Title: Response to OCC's Response dated 23rd April 2023

Technical Note 16 v1

Date: June 2023

- 1.1.2 A planning application (Ref: 21/04275/OUT) was submitted in December 2021 for a residential led mixed use development for up to 3,100 dwellings.

Figure 1.1 – Proposed Junction Layout

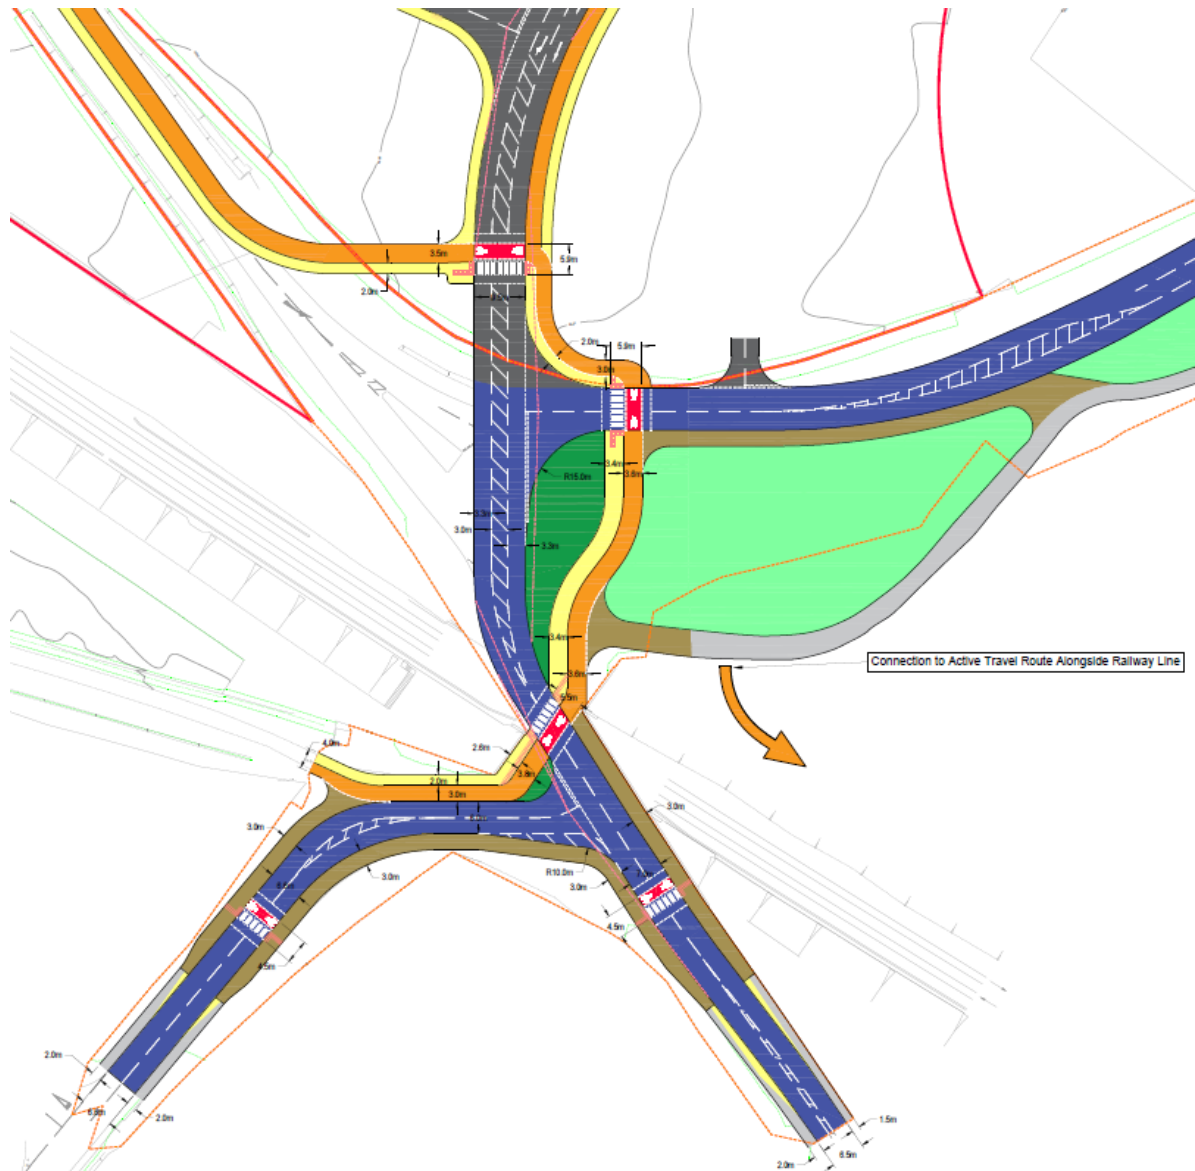
1.5.4 The design, attached as shown in **Figure 1.1**, significantly narrows down the carriageway and reallocates road space to enable significant pedestrian and cycle improvements across the junction.

1.5.5 The design seeks to introduce a 20mph zone within which pedestrians and cyclists are afforded priority through the introduction of five at grade parallel 'Tiger' crossings providing a demand responsive solution. The carriageway between the 'Tiger' crossings will be buff coloured bound surface to raise drivers' awareness that they are entering an area where vehicles are not the dominant form of transport.

1.5.6 For the main desire routes it is proposed that a minimum 5m wide active travel corridor (2m footway + 3m cycleway) will be provided. A 3m shared surface is proposed for the remaining routes around the junction. All routes will connect via the five at grade 'Tiger' crossings. The shared use cycleways on Howes Lane and Bucknell Road (southern arm) will be provided with dropped kerbs to enable cyclists to transfer to/from the off-road cycling provision from/to the carriageways.

1.5.7 The reallocation of the road space retains the ability for north/south HGV movements (i.e. between the SLR and the town centre) if the Local Highway Authority deem these vehicle movements are necessary.

1.5.8 The removal of the interim scheme signal heads and reduction in road space requires HGVs turning left from Howes Lane to use both lanes of Bucknell Road (as is the current situation and deemed suitable and safe by OCC²). The SLR will replace the majority of the east/west HGV movements and two options can be considered: firstly that the left turn HGV movements from Howes Lane will be minimal and southbound vehicle movements on Bucknell Road will be reduced, vehicles will be travelling at low speeds and as currently occurs southbound vehicles will 'give-way' to enable HGVs to undertake the manoeuvre or secondly a ban on this HGV movement is introduced.

Figure 1.2 – Historical Positions of the Bucknell Road Link Road (Illustrative)

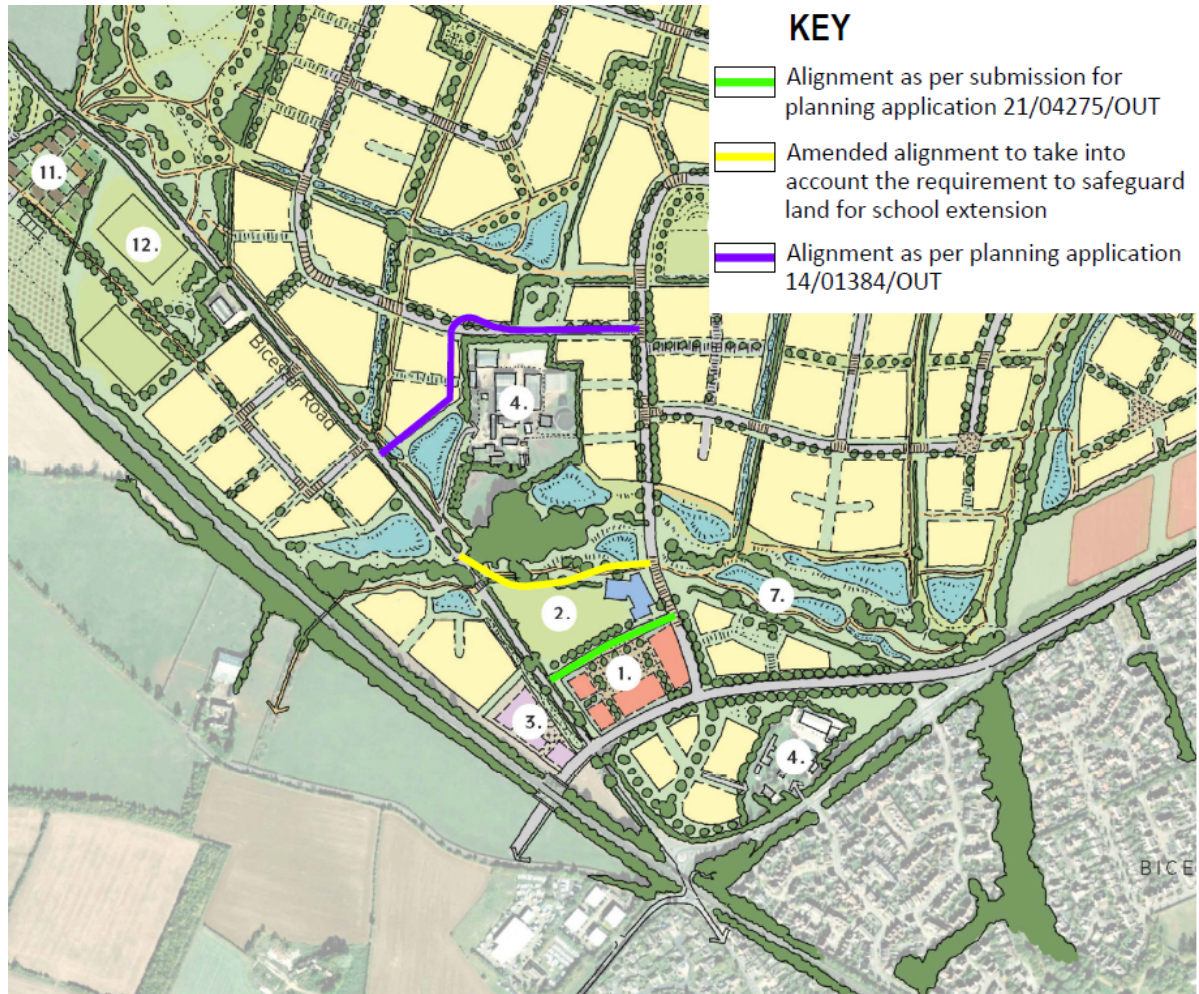
1.7.2 The Bucknell Road link road in the previous application(14/01384/OUT), commonly referred to as the 'Bucknell Hook', was moved south to enable a better masterplan layout to be delivered and to enable the link to come forward without the need for the delivery of expensive infrastructure (bridge) in the early stages of the development. Since the submission of the planning application, discussions with OCC have led to a requirement to safeguard land for a possible extension to the primary school and the link road has been moved to the north. **Figure 1.2** shows the three positions of the link road illustratively.

- 1.7.3 A journey time analysis has been undertaken to understand the difference in journey times between the positioning of the ‘Bucknell Hook’ in the previous application and the current proposal (south of Hawkwell Farm).
- 1.7.4 The assessment shows that there is no significant difference in journey times between the current and previous proposals for the Bucknell Road link road. For vehicles routing to/from the east and west the current proposal will increase the journey time by 19 seconds and for vehicles routing to/from the south the current proposal reduces the journey time by 9 seconds.
- 1.7.5 A comparison of vehicles predicted by the BTM to route through the Middleton Road / Bainton Road junction has been undertaken and is shown in **Table 1.1**.

- 1.7.6 The results indicate similar / less vehicle movements in the PM peak hour when comparing the proposed Bucknell link road to the 'Bucknell Hook'.

- 1.7.7 In the AM peak hour the BTM predicts an additional 236 – 283 vehicles travelling through the Middleton Road / Bainton Road junction which can be seen to be mainly due to the increase in background and committed traffic.

- 1.7.8 It is noted that OCC's programme of introducing 20mph speed limits includes a completed scheme within Bucknell village. The implementation of the reduced speed limit through the village will deter vehicles from using the route. As Hawkwell Village will alter the Bucknell Road environment it will meet many of the criteria for a reduction in speed to 20mph (i.e. residential frontages, school walking route, an area where greater active travel is being promoted, aid better air quality) and therefore, the 20mph speed limit could be extended further reducing the attractiveness of the route.
